Model: 190-300-100 46 inch High Vac Deck manufactured after August 1997

Date: December 11, 1997

Subject: MOWER DECK

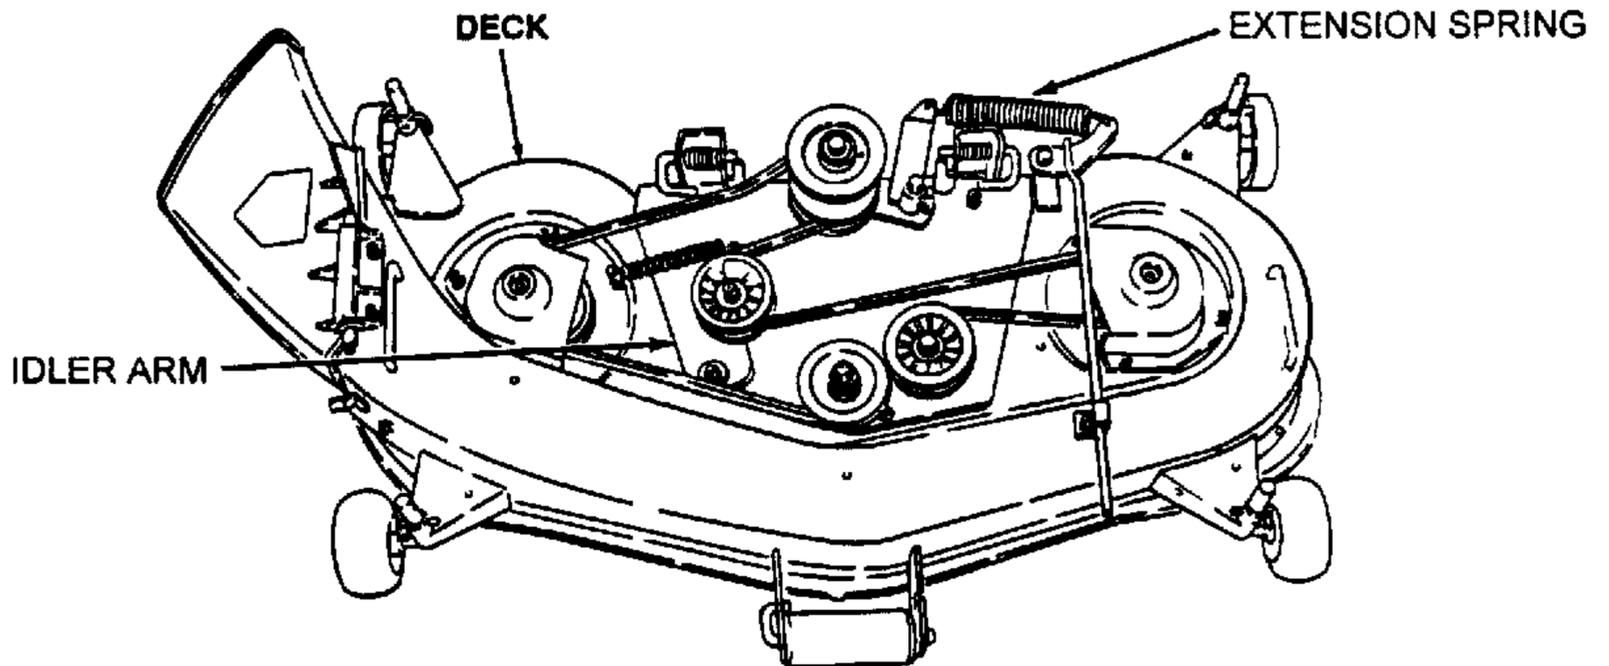
Product improvements have been implemented on the 46 inch mower deck for the Series 2000 tractors. Changes were made to improve belt life and reduce the likelihood of the belts jumping off the pulley.

In the idler arm for the spindle drive belt, the shoulder spacer (p/n 711-3272) was changed. A new shoulder spacer (p/n 711-3272A) will provide freer motion of the arm on the mower deck. Refer to the illustration below.

In order to increase tension on the PTO belt, the extension spring (p/n 732-3115) was changed. If the deck is properly adjusted, the new extension spring (p/n 732-0861) will maintain proper belt tension. Refer to the illustration below.
